# SERVICE Counselor

STUDEBAKER-PACKARD CORPORATION

VOL. 30, NO. 3

MARCH, 1956

### Ignition Cable Support Brackets

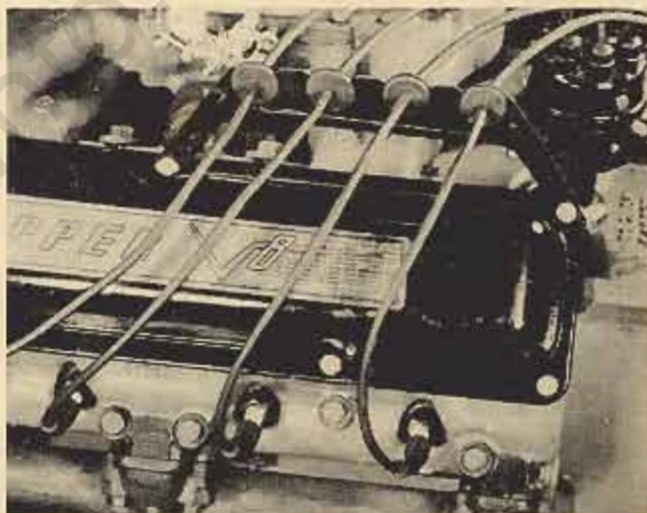
Occasional reports have been received of the V 8 Engine failing to respond smoothly on acceleration particularly in the 20 to 40 M.P.H. speed range. This condition is generally diagnosed as faulty carburetion, but in many cases it is caused by a cross-fire between No. 5 and No. 7 cylinders.

Cross-firing may be caused by pinched ignition cable wires between fingers of the cable supports breaking the wire insulation, separation of the dipped rubber from the cable supports or wires running parallel too close to one another for enough distance to permit capacitive coupling.

Number 7 cylinder fires 90° crankshaft travel after No. 5 cylinder, cross-firing will cause No. 7 cylinder to fire at the same time No. 5 fires as they both are charged with fuel.

Should cross-firing occur, examine the ignition cables for broken insulation and if found satisfactory, install new ignition cable supports as shown in the illustration. The new supports spread the cables farther apart and the rubber grommets hold the cables at a greater distance from the metal supports.

1. Lift the ignition cables from between the support fingers on all four supports, remove and discard the cylinder head supports and the supports under the coil.

2. Install the new supports as shown in the illustration by attaching the supports under the center and rear cap screws for the rocker cover. Only one support is used per side.
3. Install the grommets on the cables and position the grommets in the supports leaving the cables at the approximate length shown.
4. It will be necessary to cut off some of the cables to obtain proper length between the support and the distributor cap. Remove the cables one at a time from the distributor cap, remove the cable terminals and cut off the amount of cable as listed and reinstall the terminal and cable in the cap.

No. 3 Cut off  $2\frac{1}{2}$ "  
No. 4 OK  
No. 5 Cut off  $5\frac{3}{4}$ "  
No. 6 Cut off  $1\frac{1}{4}$ "  
No. 7 Cut off  $7\frac{3}{4}$ "  
No. 8 Cut off 7"

No. 3 Cut off  $5\frac{1}{2}$ "  
No. 4 OK  
No. 5 Cut off  $5\frac{3}{4}$ "  
No. 6 Cut off  $1\frac{1}{4}$ "  
No. 7 Cut off  $7\frac{3}{4}$ "  
No. 8 Cut off 7"

- Part No. 6484553 Ignition Bracket and Cable Set  
55th-56th Series  
Part No. 6484555 Ignition Bracket Set 55th-56th  
Series  
Part No. 6484554 Ignition Cable Set 55th-56th  
Series

Fig. 1

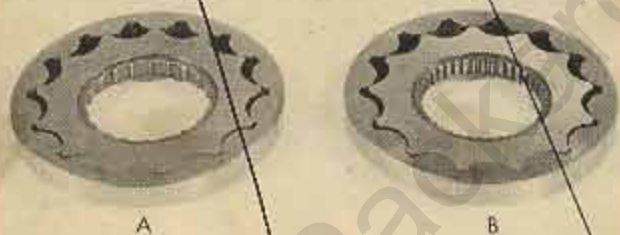
Several reports have been received of worn or stripped splines on the converter pump shaft where it engages with the front oil pump rotor and in some cases, the splines in the rotor were worn or stripped. This condition may occur in 54th Series Gear-Start transmissions, 55th and early 56th Series Ultramatic transmissions.

"A" figure 1, shows the front oil pump rotor having 20 internal splines that is used in 54th Series Gear-Start, 55th and early 56th Series Ultramatic transmissions.

56th Series transmissions starting with serial numbers A-9681, B-6012, C-1143, D-1862 have front oil pumps with the direct clutch passage in the rear and also have the rotors with 40 tooth splines on the internal driving section, "B" figure 1.

New rotors with 40 splines and front pump assemblies with 40 spline rotors have been released for service replacement and are listed for your ready reference.

Fig. 2

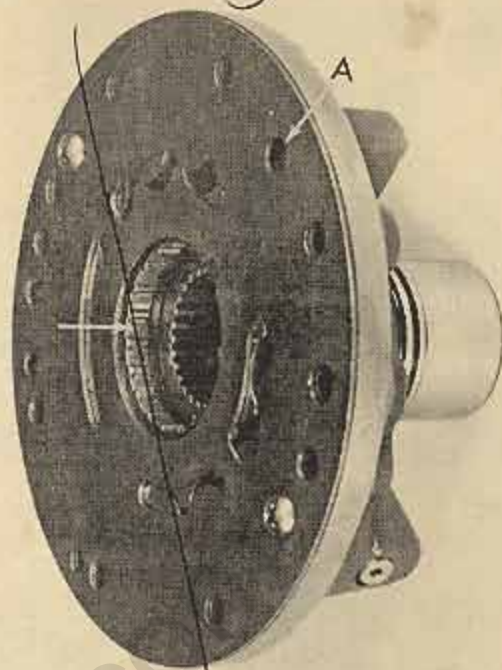
On 54th Series Gear-Start, all 55th and 56th Series Ultramatic transmissions up to transmission serial number A-6481, B-4741, C-1057, oil pressure for the direct drive clutch came out of a passage on the front side of the pump. See "A" figure 2. The oil pressure is directed through a passage in the bell housing, then past the open splines in the rotor to the input shaft.

Fig. 3

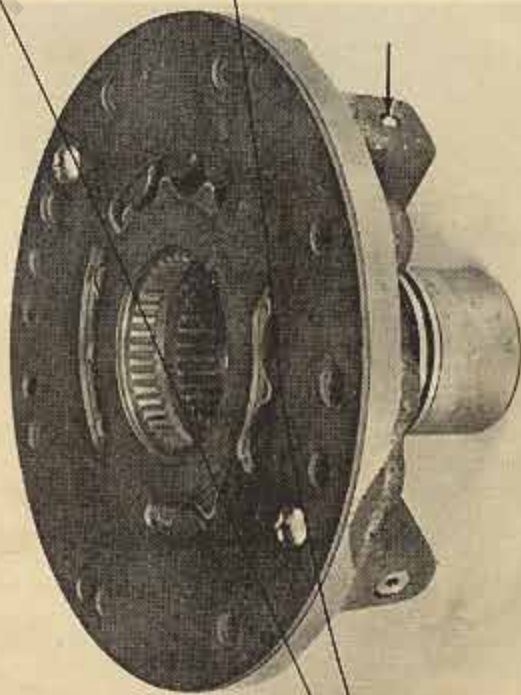
56th Series transmissions after the above serial numbers have front oil pumps with the direct clutch oil passage in the rear side of the pump. "See arrow figure 3," also note the oil passage hole is not in the front plate. However, these pumps have the 20 tooth

splined rotors. (40 tooth rotor is shown in the illustration.)

The  $\frac{1}{8}$ " holes are not required in the above listed Converter Shaft because the direct clutch oil passage is in the rear side of the pump body.

Fig. 4

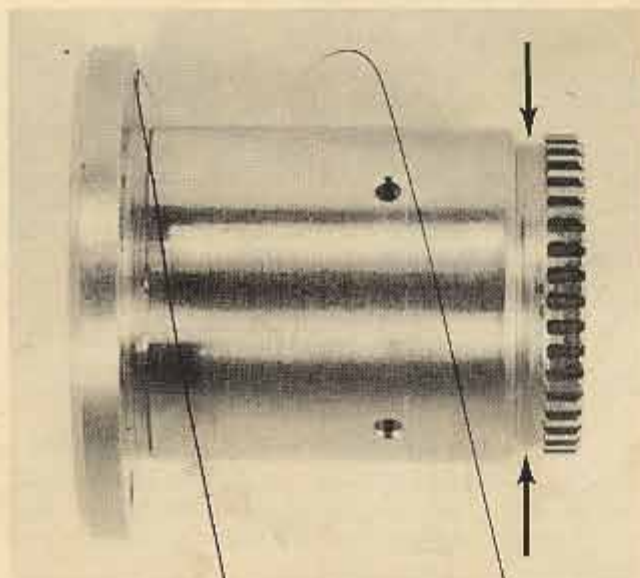
The pump assembly listed above has the oil passage in the front side of the body and the rotor has 40 splines, therefore it will be necessary to drill six  $\frac{1}{8}$ " holes through the annular groove just back of the splines in the converter shaft to provide an oil passage to the direct drive clutch. "See arrows figure 4." This also applies when replacing the rotor assembly. Be sure to remove burrs from edges of  $\frac{1}{8}$ " holes and internal bushing after drilling.

## Push Button Control Bent Actuator Fingers

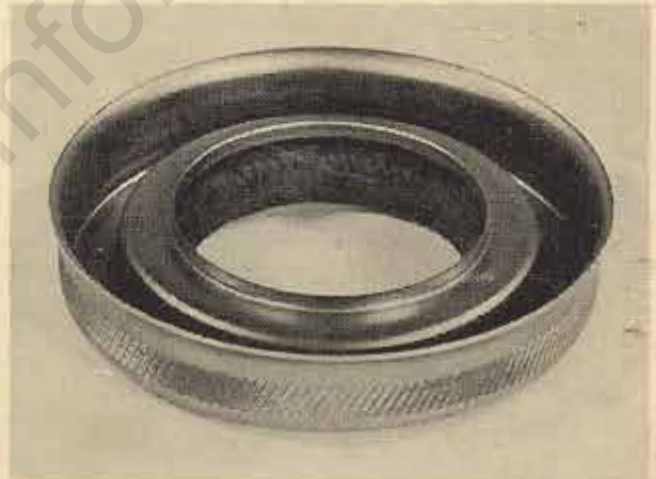
A few push button actuator assemblies have been returned for various reasons. Upon inspection in most all cases, it was found that one or both end fingers were bent so they would not touch the contact segment.

Bent end fingers is generally caused by actuator overtravel, which permits the finger to drop down at the end of the segment therefore, bending a finger when the actuator is operated. Overtravel may be caused by improper electrical testing or may occur during installation of the unit.

Remove the actuator cover and finger assembly. If bent fingers are found, they can be straightened by holding the upper portion of the finger with pliers and straightening the lower end with long nose pliers. Be sure the finger has the same contour as the other fingers and has not been weakened after being bent and straightened, also check for burned fingers.

Place the contact finger assembly in position with the fingers above the contact segment. Carefully slide the assembly toward the contact segment until the fingers are deflected only enough to allow alignment of the screw holes. Install and tighten the three screws evenly.

**IMPORTANT:** In connecting wires to the shift relay be sure to connect "light gauge" orange with black tracer wire to "L" or #4 terminal and pink wire to "M" or #6 terminal. Connect "heavy gauge" gray wire to "D" or #1 terminal and brown wire to "F" or #3 terminal. If any of these wires are reversed, the actuator will overtravel when pushing the buttons. (Refer to wiring diagram—Service Counselor Vol. 30, No. 1, January 1956.)
